Model: KV-20M42, KV-20S90**No.** 535**Subject:** Potential 30MHz Interference**Date:** May 17, 2001**Symptom:**
(1341)

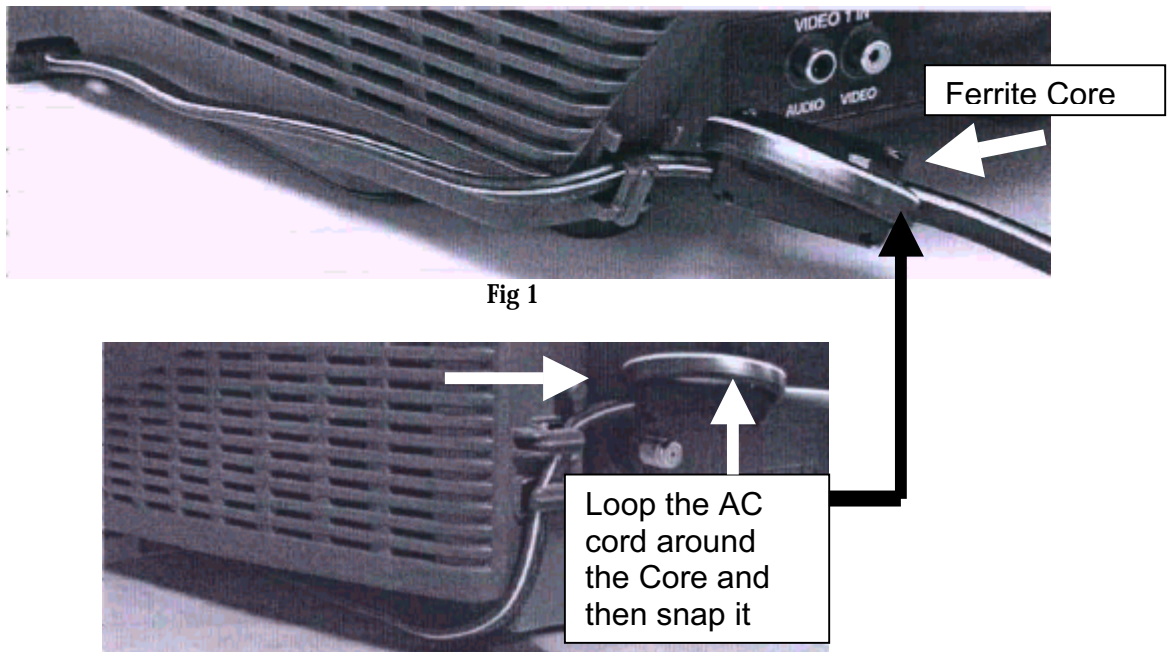
When the TV is on; other devices may pick up interference from the TV.

In order to improve the slight possibility of interference at 30MHz a Ferrite Core has to be added to the AC cord at the end closest to the rear cabinet. See fig 1

Model	Description	Part Number	Serial Number range that need this Ferrite Core
KV-20M42	Ferrite Core	1-500-386-11	4170001-4175650
KV-20S90	Ferrite Core	1-500-386-11	4000001-4000150
